Effective Date: 2/6/13	Service Bulletin	Revision B
Warranty: Depends on Install Date	No SPM Detected or Error 02A0 on Climb Mill	<b>Revised Date:</b> 10/23/13
Time Required: 60 Minutes	Models Affected: All CS17 or CS22 Climb Mills (excludes CS23)	<b>Prepared by:</b> Kevin Oeltjenbruns

No SPM Detected or Error 02A0 is present on the console or the unit goes into Pause Mode without prompting.

FIGURE C

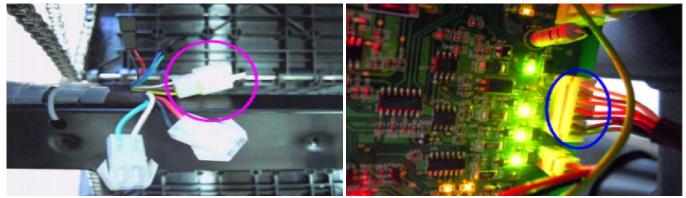
- All CS17 or CS22 Climb Mills (excludes CS23)
- Kevin Oeltjenbruns
- 3. If neither software nor the speed sensor is causing the issue, the next thing to check is the brake.
  - Remove the Matrix logo cover from each side of the unit. a.
  - b. Check the connection of the brake wire at the extension (Figure C) and LCB (Figure D).

- c. Unplug the brake wire from the extension wire which runs to the LCB.
- d. Test the brake by taking a resistance reading on pins 1 & 2 of the brake wire. The resistance reading should be approximately 52  $\Omega$ .

- If the resistance reading is less than 52  $\Omega$  (or if there is no resistance reading), replace the brake.
  - If the resistance reading is correct, replace the brake extension cable.

### FIGURE I

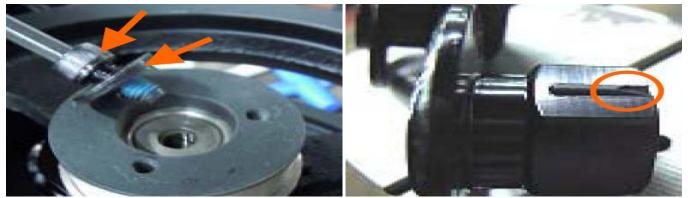
- e. Install a new screw / washer to replace the parts removed in Step 4d (Figure I). *NOTE:* The new screw will be 15mm long (instead of 10mm) and the new washer will be 3 mm thick (instead of 1.5mm).
- f. Install a new cushioned nut using the 3 screws removed in Step 4c. The new nut has a small bevel on the cushion (Figure J).
